Cable Length Change

Instinct Dual Abdominal/Lower Back (9IL-D6330-13BSS)

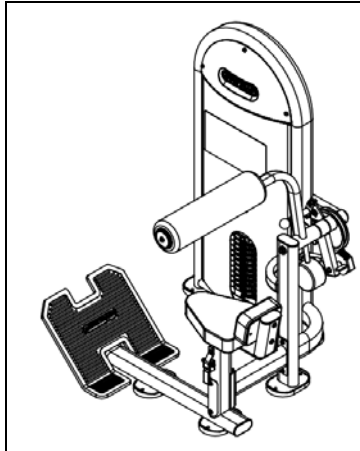
To ensure you are ordering the proper cable for the Instinct Dual Abdominal/Lower Back machine, you must check the serial number of the machine.

Serial Number Range	Part Number	Cable Length
Before ID-D1035216	730-2150	1050mm
After ID-D1035216	730-2841	1145mm

To update a machine made before serial number ID-D1035216 to accommodate the longer cable (730-2841), the entire cam assembly will need to be changed (PN: 730-2840-KT).
